UNITED STATES
DEPARTMENT OF THE INTERIOR
BUREAU OF LAND MANAGEMENT

SUNDRY NOTICES AND REPORTS ON WELLS
Do not use this form for proposals to drill or to re-enter an abandoned well. Use form 3160-3 (APD) for such proposals.

1. Type of Well <input checked="" type="checkbox"/> Oil Well <input type="checkbox"/> Gas Well <input type="checkbox"/> Other		8. Well Name and No. JACKSON A 28
2. Name of Operator BURNETT OIL CO., INC.		9. API Well No. 30-015-34766
3a. Address BURNETT PLAZA - SUITE 1500 801 CHERRY STREET FORT WORTH, TX 76102	3b. Phone No. (include area code) 817-382-5008 Ext. 6326	10. Field and Pool, or Exploratory CEDAR LAKE GLORIETA YESO
4. Location of Well (Footage, Sec., T., R., M., or Survey Description) Sec 13 T17S R30E 990FNL 1650FEL		11. County or Parish, and State EDDY COUNTY COUNTY, NM

**BURNETT OIL COMPANY, INC.
BLOWOUT PREVENTER &
CHOKE MANIFOLD DIAGRAM
2000 PSI WORKING PRESSURE**

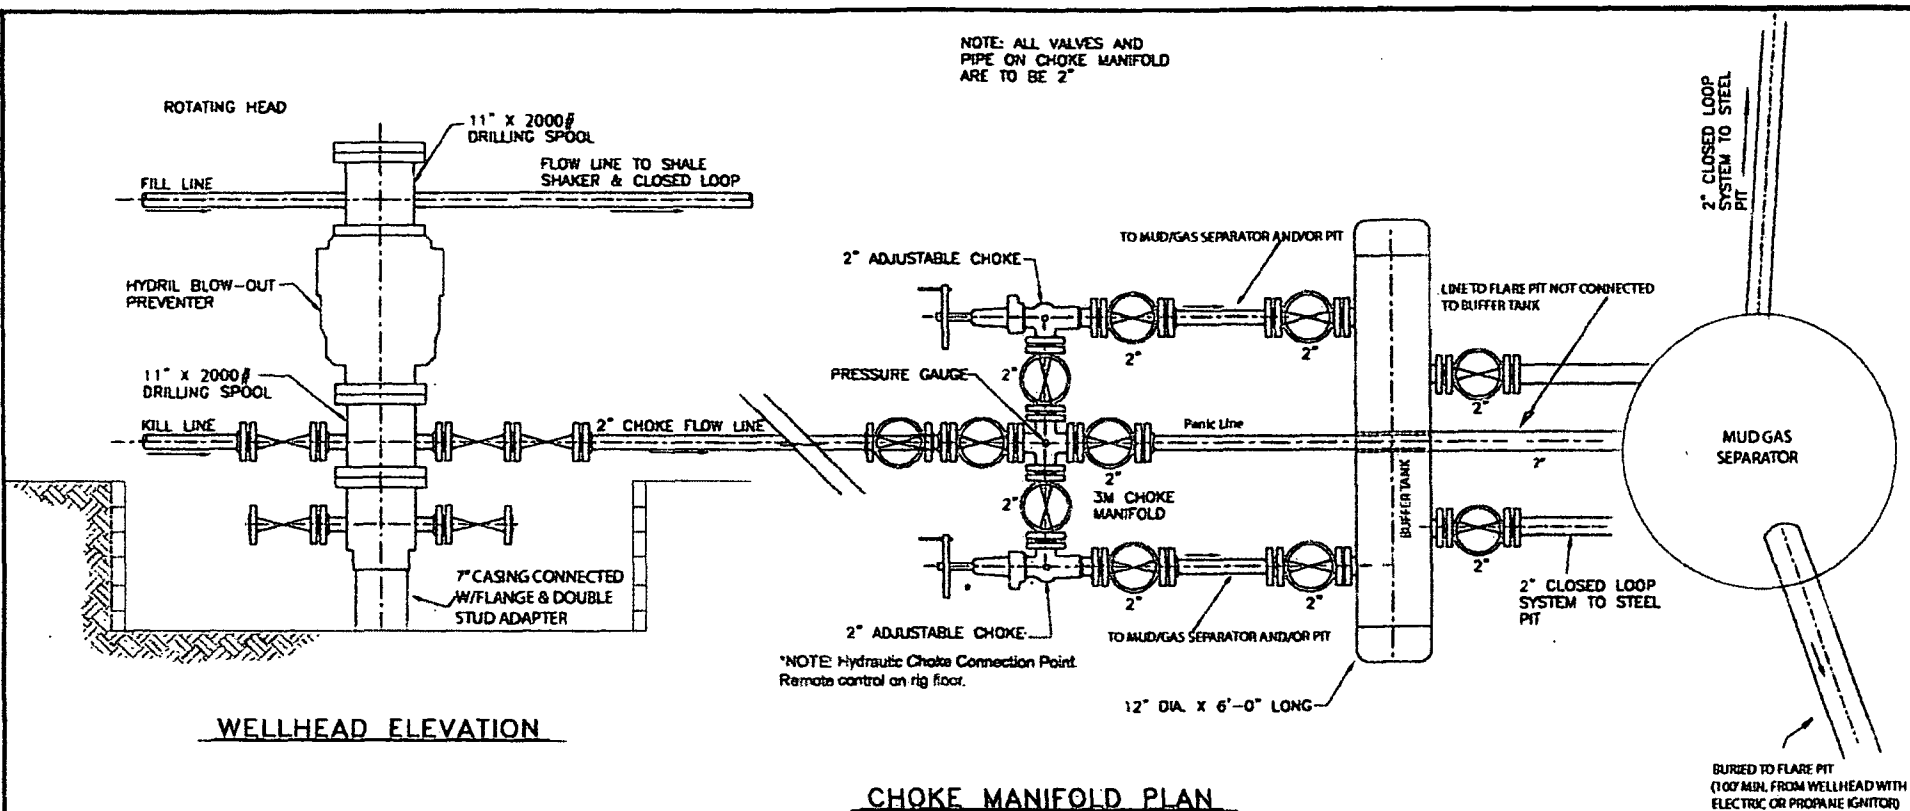
Burnett Oil is requesting a change to the previously approved BOP/Choke Manifold Diagram for this deepening. Please see the attached revised diagram.
